### ADDENDUM NO. 1 - OUTLINE AND SUMMARY INFORMATION

Project Name: MSU Stadium Lots

PPA No.: 22-0012

Date: 03-27-2024

SHEET  
**CU1.4**

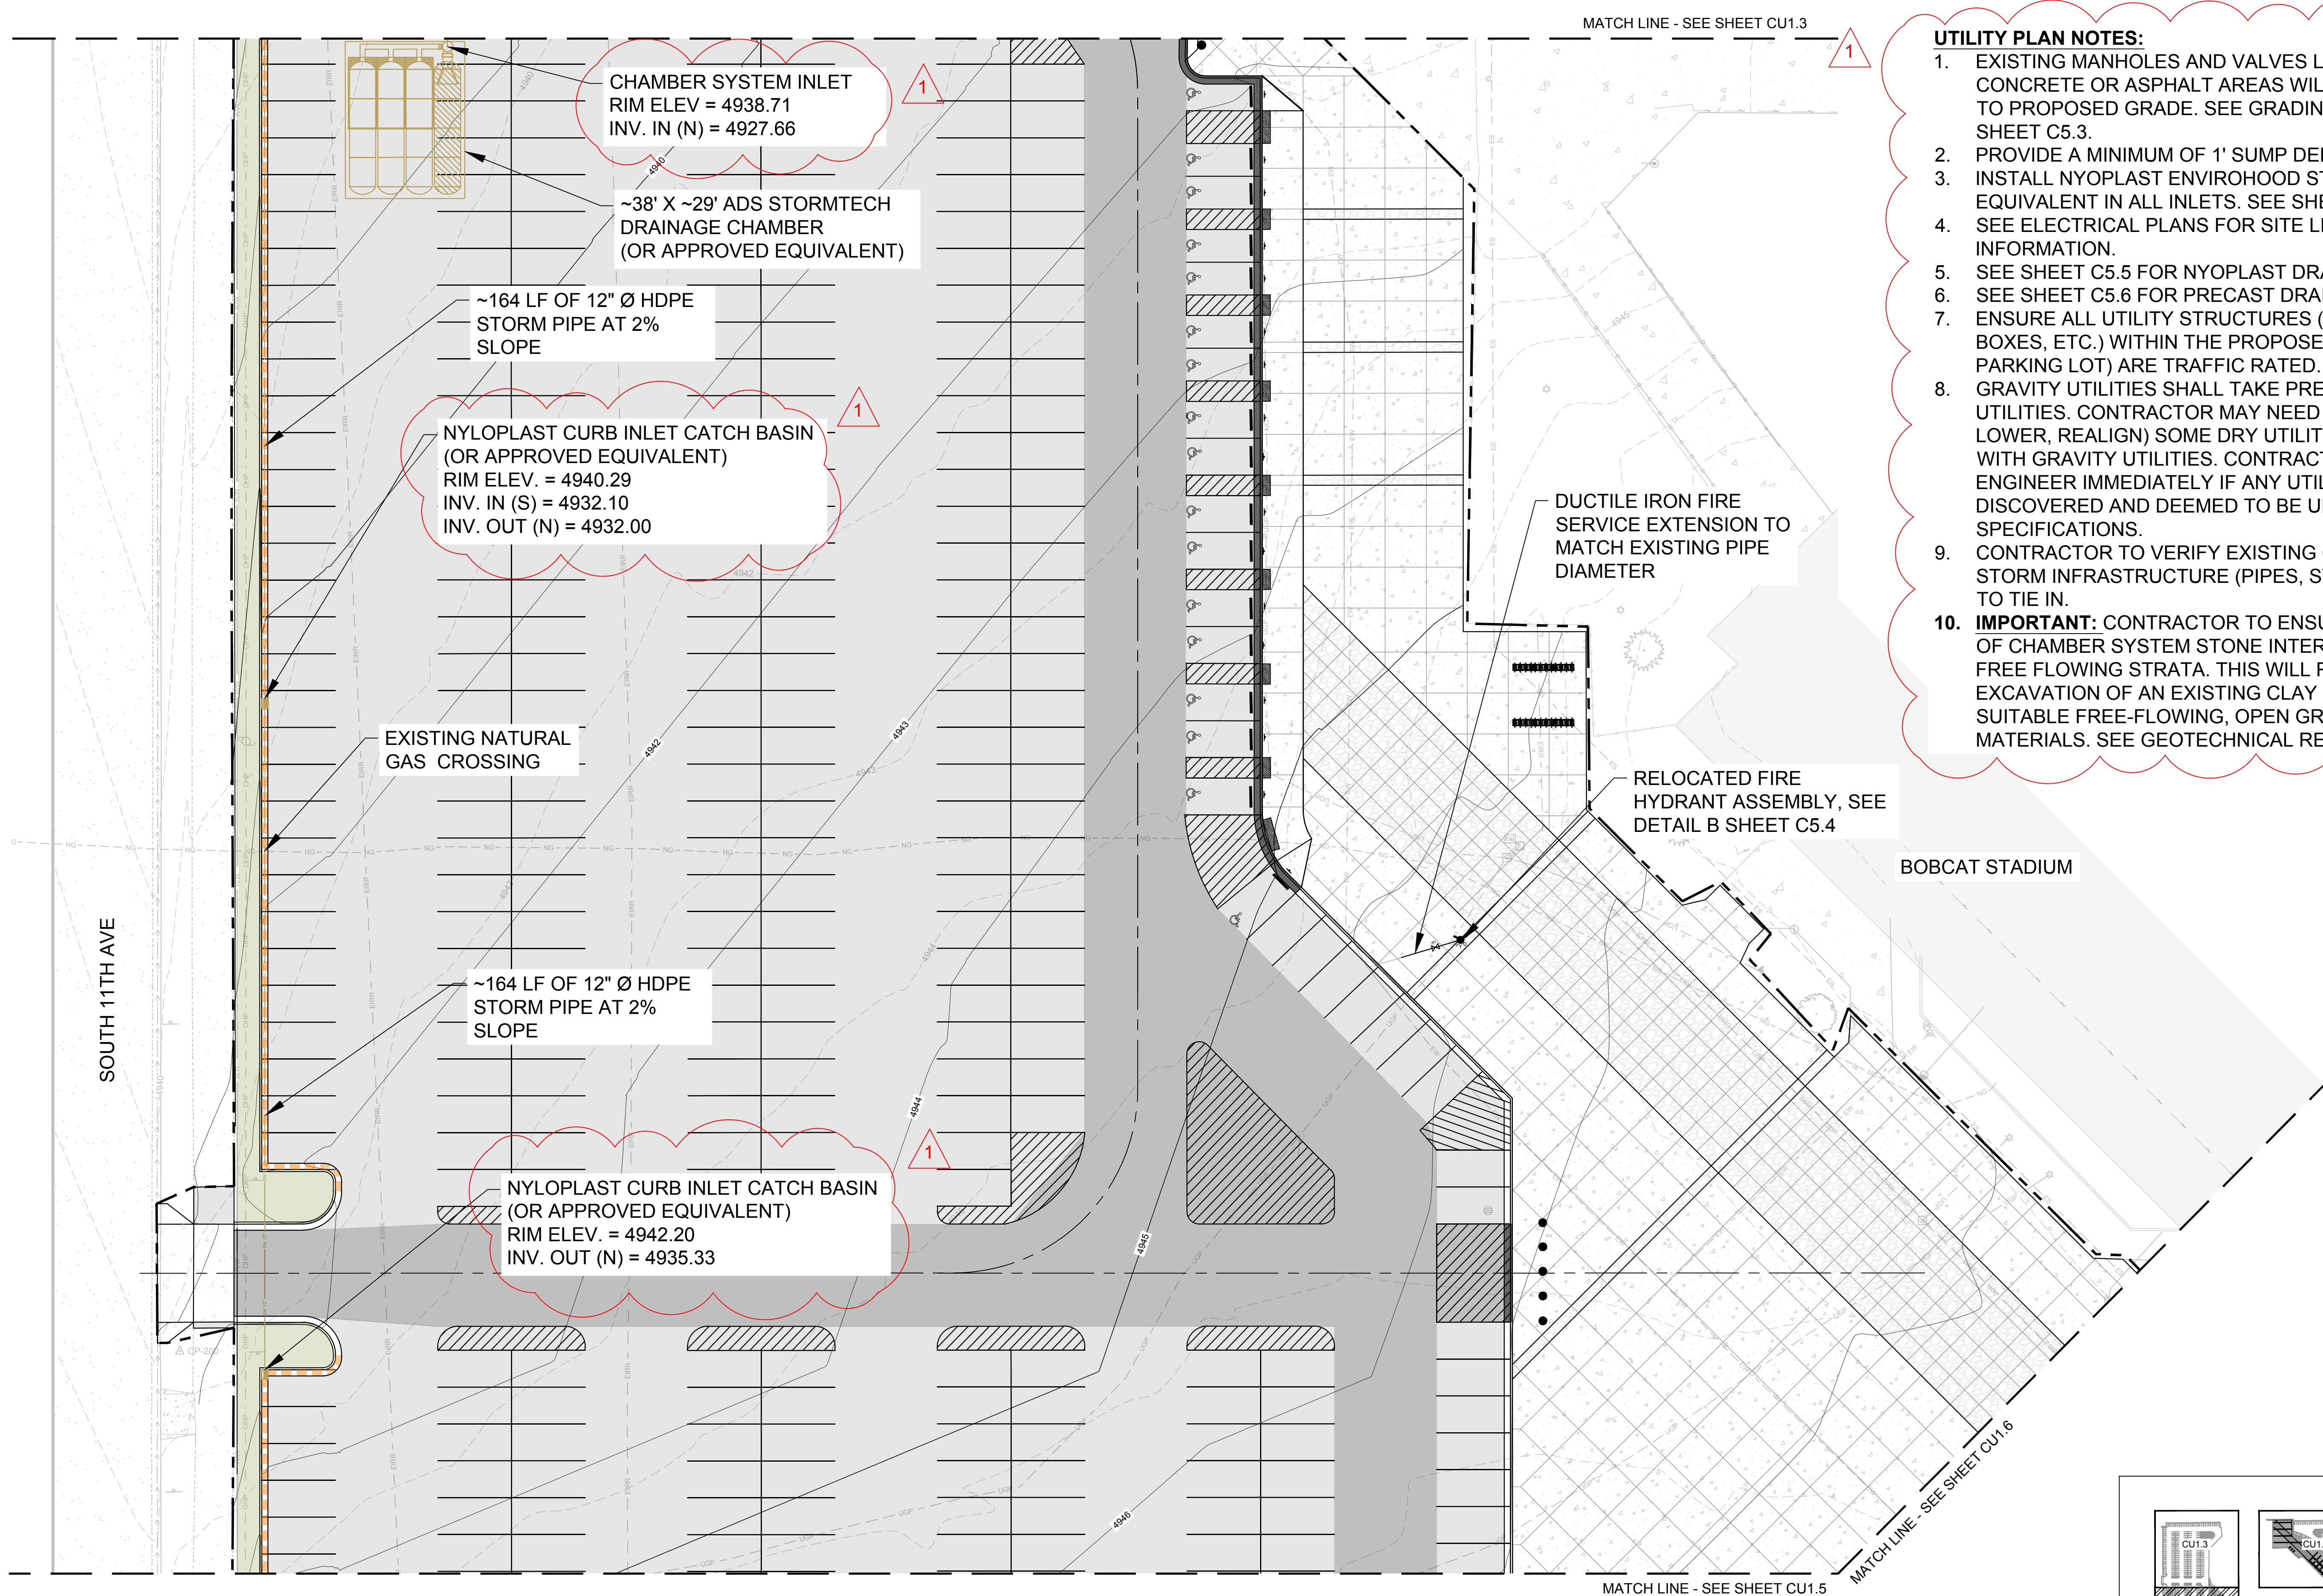
- A. ADD - GENERAL NOTE: General note #9 was added to provide the contractor further clarification on tying into existing storm infrastructure.
- B. REVISE – STORM INLET INVERTS: Storm drainage inverts were raised on this sheet with the intent to minimize trenching/excavation costs.

SHEET  
**CU1.5**

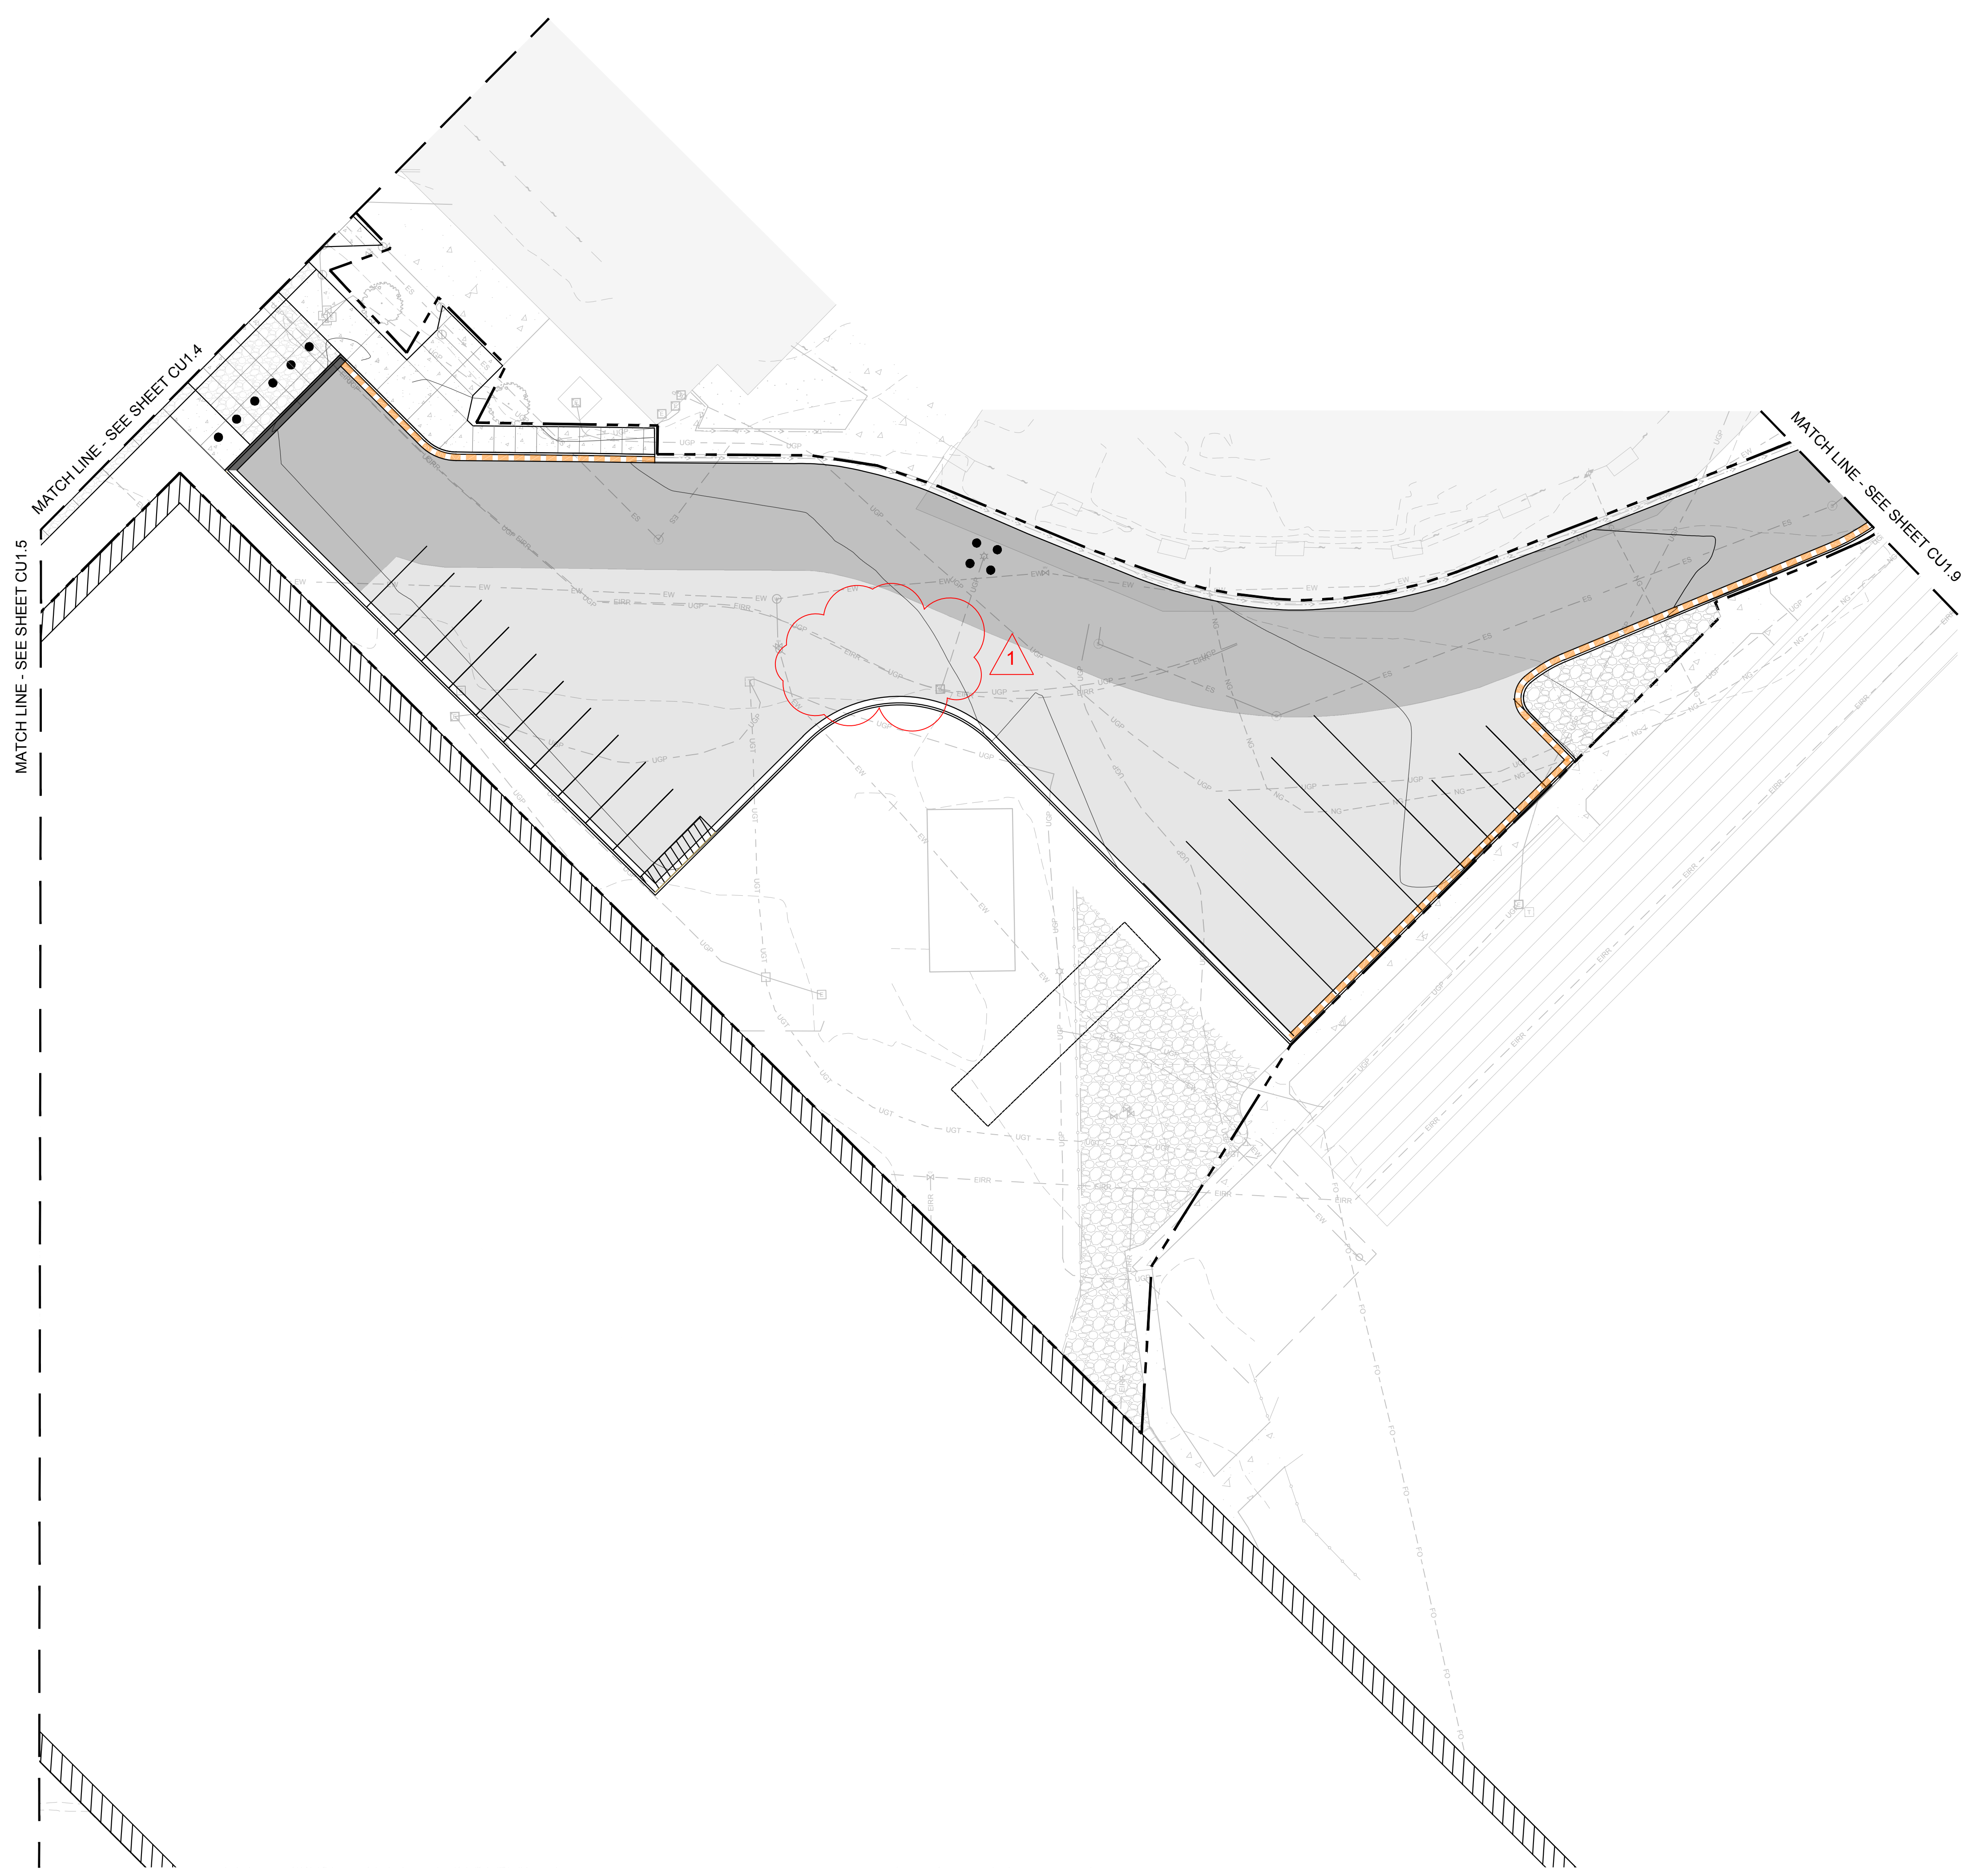
- A. ADD - GENERAL NOTE: General note #9 was added to provide the contractor with further clarification on tying into existing storm infrastructure.

SHEET  
**CU1.6**

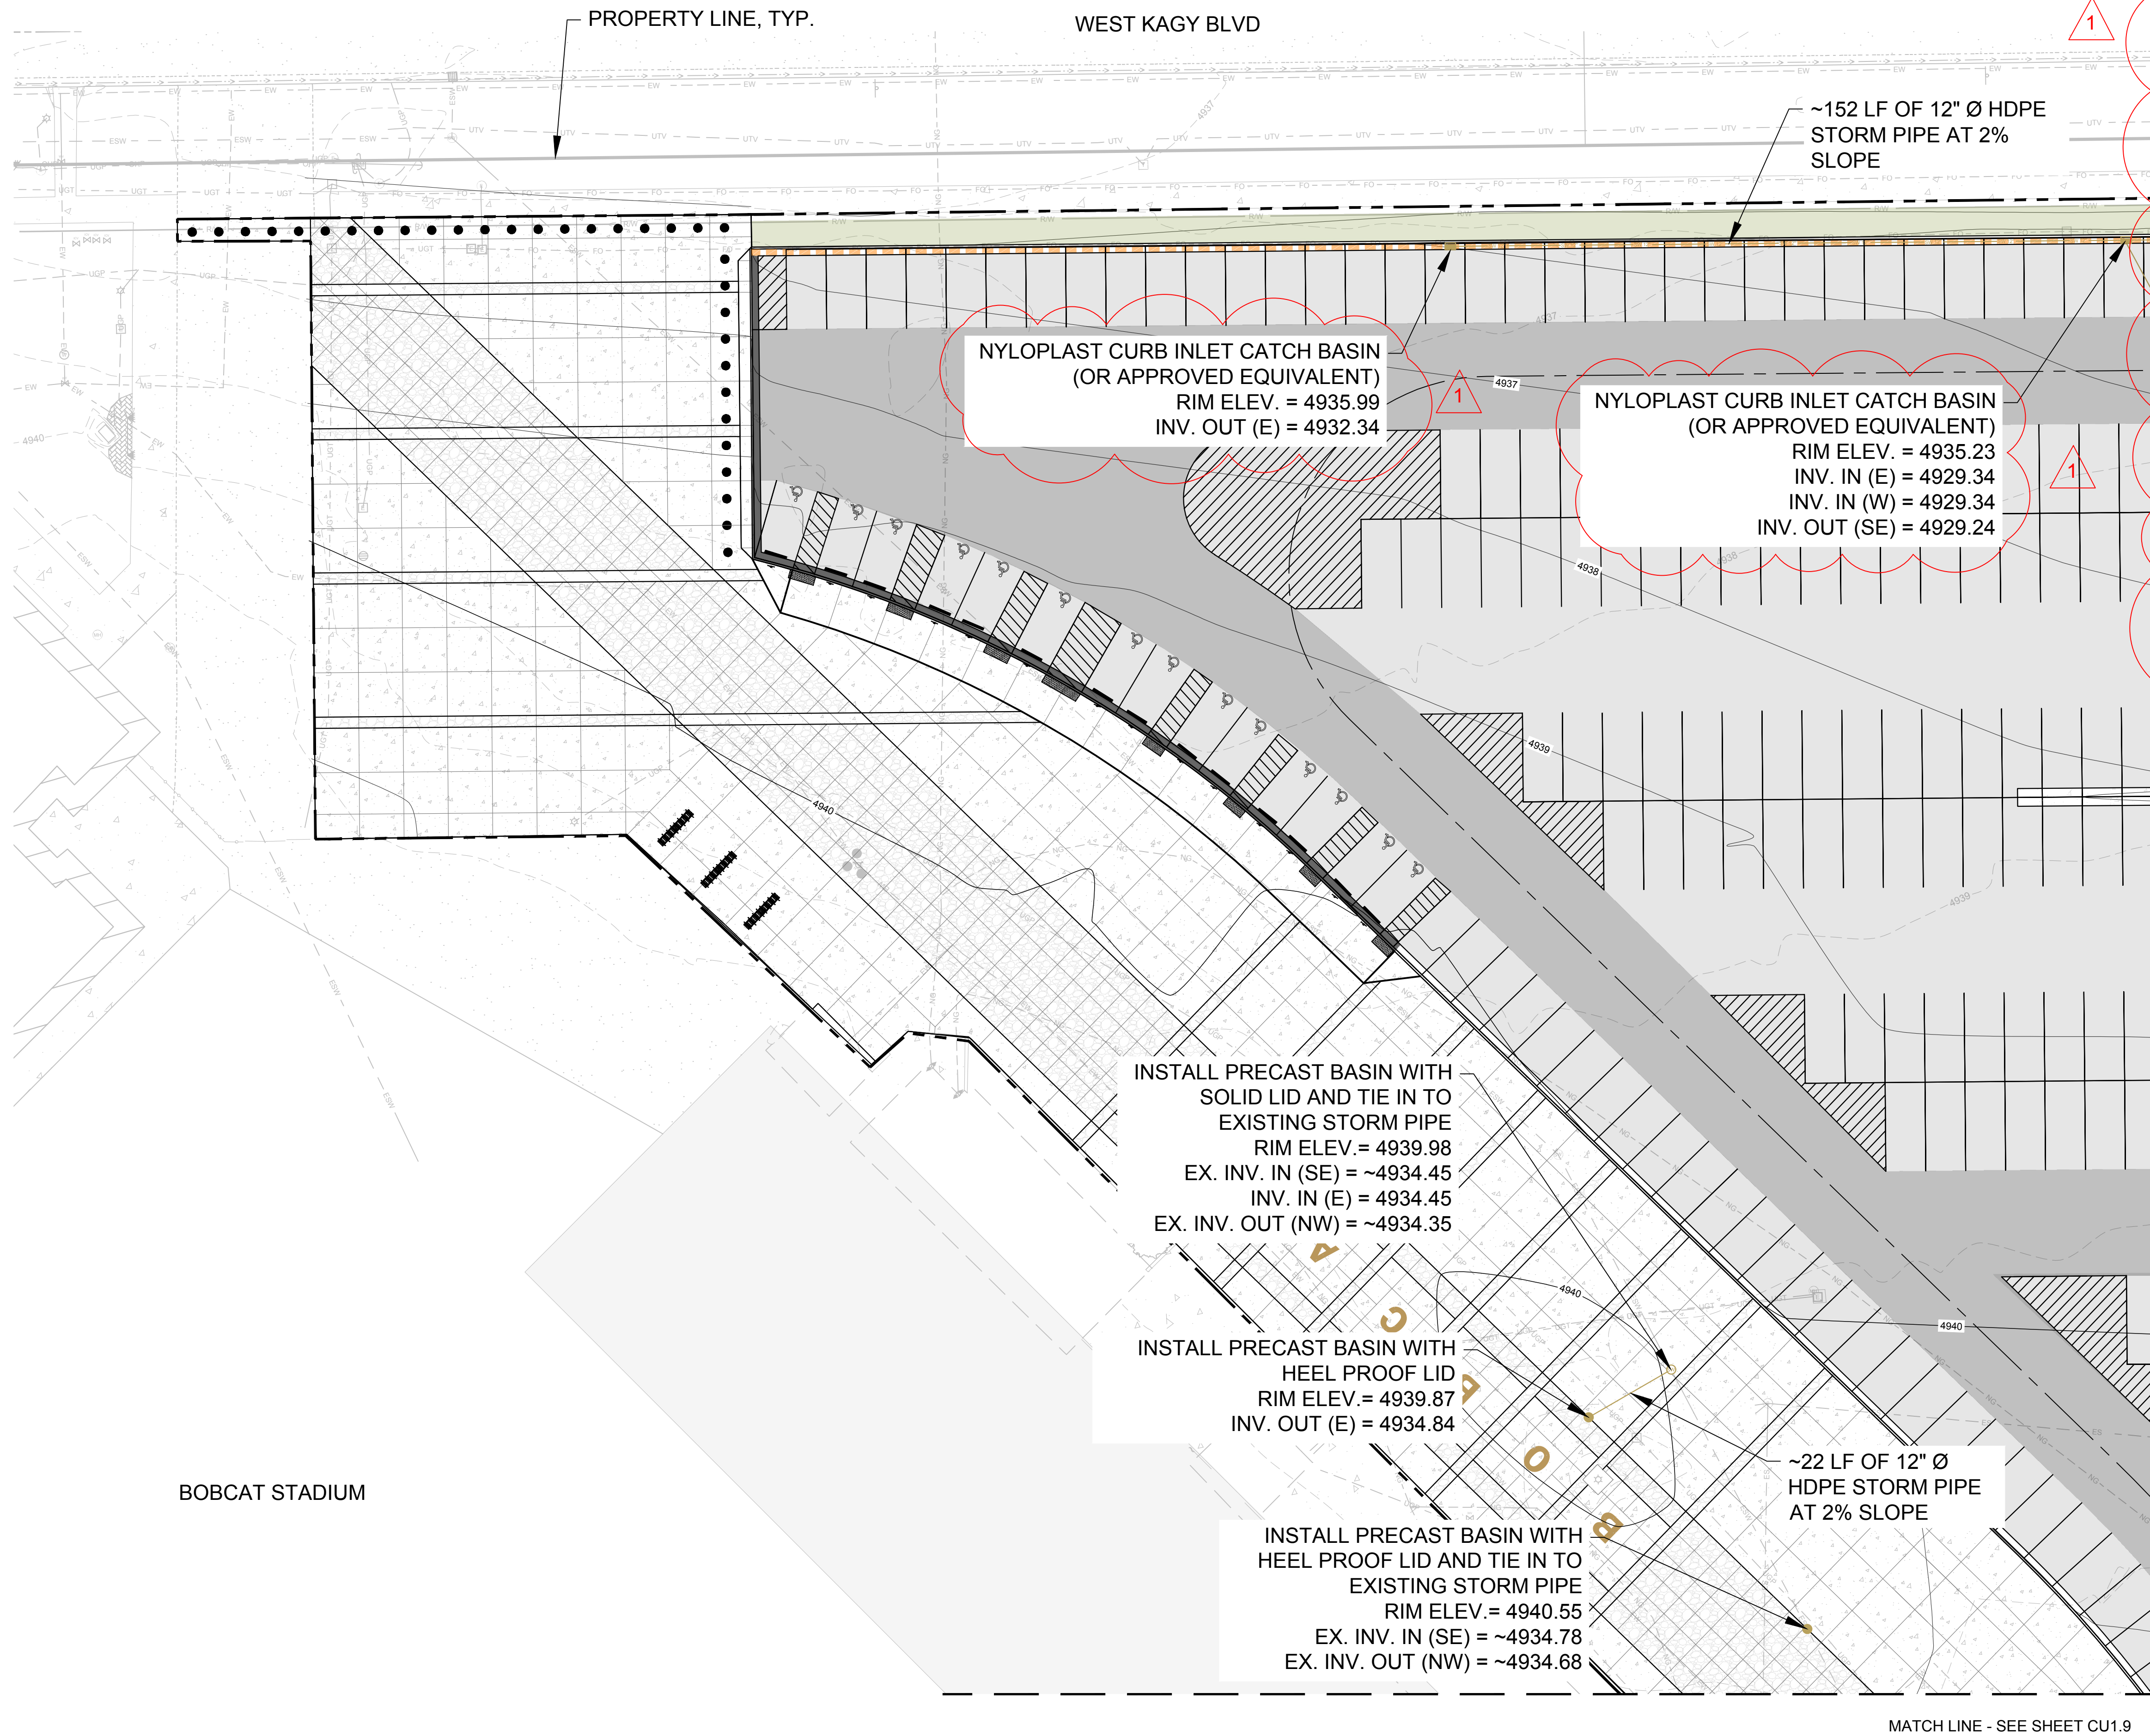
- A. ADD - GENERAL NOTE: General note #9 was added to provide the contractor with further clarification on tying into existing storm infrastructure.
- B. REVISE - REMOVAL AND REPLACEMENT OF EXISTING HYDRANT: The removal and relocation of the existing hydrant shown on this sheet is no longer a part of this scope of work. Instead, this specific hydrant will be removed and relocated under the indoor practice facility project.
